2.0 Parker Hydraulic Pump Consolidation (Fan/LSTA/Hydraulic Chute)

Date: July 14, 2021
Bulletin Name: FDM-PB-004
Model: Oshkosh S-Series
Units Affected: 2.0 Front Discharge Mixers

Purpose: This bulletin outlines the specific Parker pump version differences.

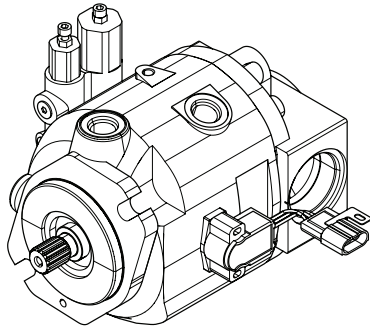
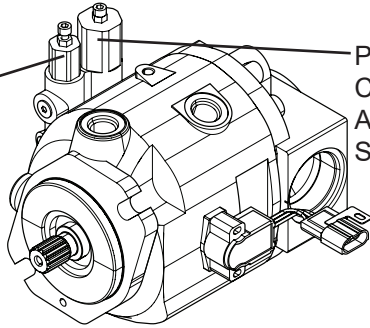
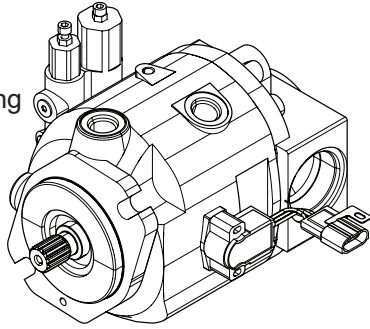
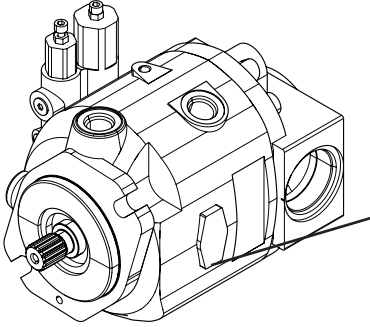
Part No.	Description	Image
A000P021	Initial pump Pump released 09/2019	
A000R100	Specified Parker's matte black topcoat to prevent corrosion, corrected steel plug locations, added tamper-proof caps for pressure compensator screw and load sense screw Pump released 09/2020	 Load Sense Adjustment Screw Pressure Compensator Adjustment Screw
A000T409	Changed the load-sense pressure setting to improve fan stability at low fan speeds. Pump released 10/2020	 Load Sense Pressure Setting changed from 290 PSI to 200 PSI
A000V296	Removed the swash plate displacement sensor. Pump released 12/2020	 Sensor removed

NOTE: When replacing a A000R100 or A000T409 pump with a A000V296 pump and have display software prior to version 3.0.0, the driver display diagnostic screen value for pump displacement will be blank.

Figure 1. Parker Hydraulic Pump Connector

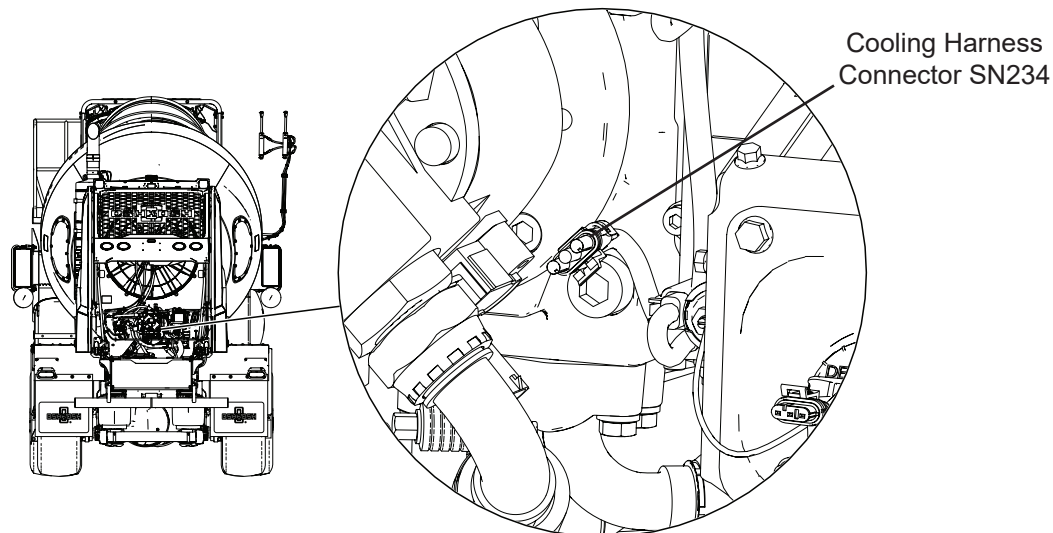
Coil up and tie off cooling harness connector SN234 when replacing an earlier pump with pump A000V296, see Figure 1.
